(Add No. 1, Item II. 6)

VILLAGE OF SALADO, TEXAS
 0.200 MGD WASTEWATER TREATMENT PLANT
 GRADING AND EROSION CONTROL PLAN

SHEET NO. **G-10**
 OF **11**

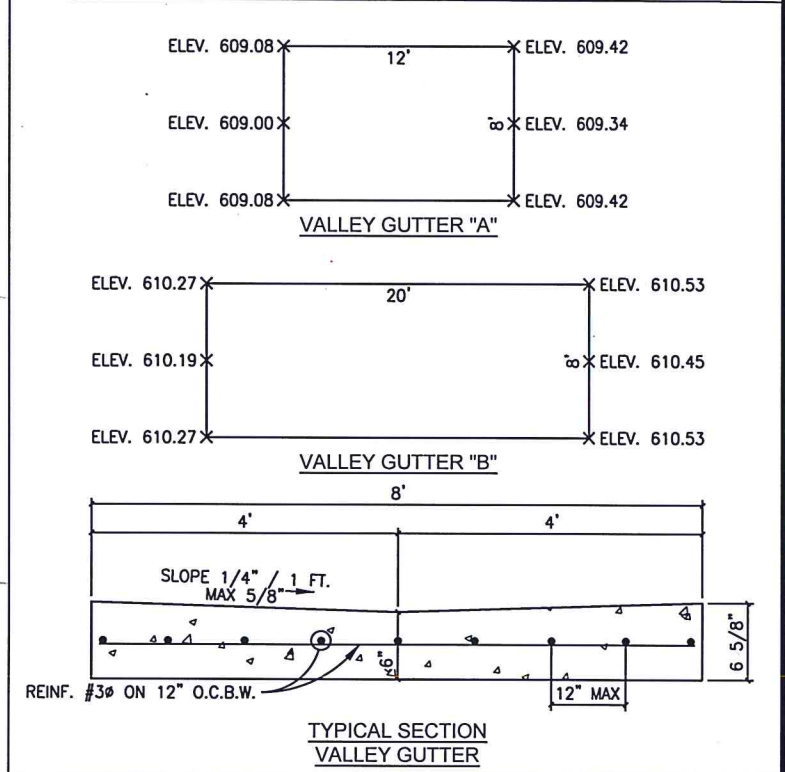
- NOTES:**
1. CONTRACTOR SHALL FURNISH AND INSTALL A STABILIZED CONSTRUCTION ENTRANCE AT THE END OF THE PAVED SURFACE OF SHEPPARD DRIVE. STABILIZED CONSTRUCTION ENTRANCE SHALL CONSIST OF 3"-5" OPEN GRADED ROCK AS DETAILED ON SHEET D-06 OF THE PLANS. THE GENERAL LOCATION OF THE ENTRANCE IS SHOWN ON SHEET G-01 OF THE PLANS.
 2. SEE SHEET D-06 FOR DETAILS OF ROCK BERM AND SILT FENCE.
 3. CONTRACTOR SHALL PREPARE STORMWATER POLLUTION PREVENTION PLAN AND SUBMIT TO TCEQ TO OBTAIN A PERMIT. THE COST FOR SUBMISSION TO TCEQ, RECEIVING A PERMIT AND IMPLEMENTING, INCLUDING FURNISHING AND INSTALLING, MAINTAINING AND REMOVING EROSION CONTROL MEASURES SHALL BE INCLUDED IN THE LUMP SUM BID ITEM FOR CONSTRUCTION OF THE 0.200 MGD WWTP. NO SEPARATE PAYMENTS WILL BE MADE FOR INSTALLING, IMPLEMENTING AND REMOVING EROSION CONTROL MEASURES.

1	10/2/17	Final Bid Set	RNK
2	10/23/17	Added Erosion Control	RNK
NO.	DATE	REVISION	BY
Plot Date: Oct 23, 2017 - 1:28pm Plotted By: DLK
